3070-88

S E R V I C E N O T E

Agilent Medalist i3070 and i3070 Series 5 In-Circuit Test Systems

Bios 1.12 version in rp5700 causes longer time to load board directory across network

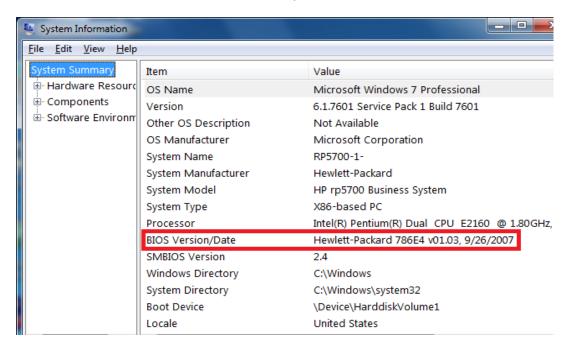
The Hewlett Packard rp5700 PC model may take a longer time to load the board directory or startup "Push Button Debug" if the board directory resides in the network server. The above symptoms occur on the rp5700 that uses **Bios version 1.12**.

You can find the BIOS Version/Date as shown in the figure below. Please follow the steps under the Solution/Action in this service note to update to **Bios version 1.20**.

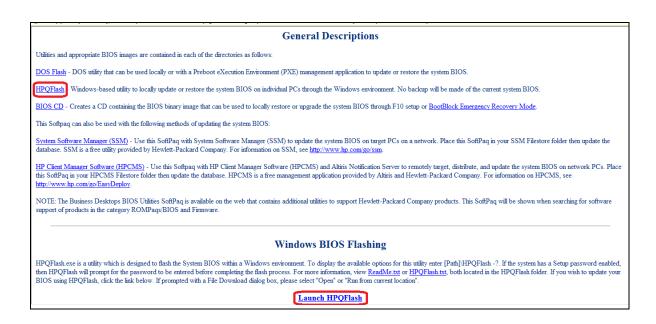
You must perform the following steps to improve the loading time.

- 1. Update the Bios
- 2. Re-install Windows Operating System from scratch

- Download the Bios file "SP54250.zip" at www.agilent.com/find/i3070patches
- Unzip the file and double click to extract it to C:\swsetup\SP54250 directory
- After the extraction, a webpage with the title "Bios Flash Update" will open automatically
- Click on HPQFlash to jump to "Launch HPQFlash"
- Then, click on "Launch HPQFlash"
- Follow the instructions given to update the Bios.

Reinstall the Windows operating system from scratch after completing the Bios update. Next, reinstall the ICT software. Finally, restore all the files and data that were backed up earlier.
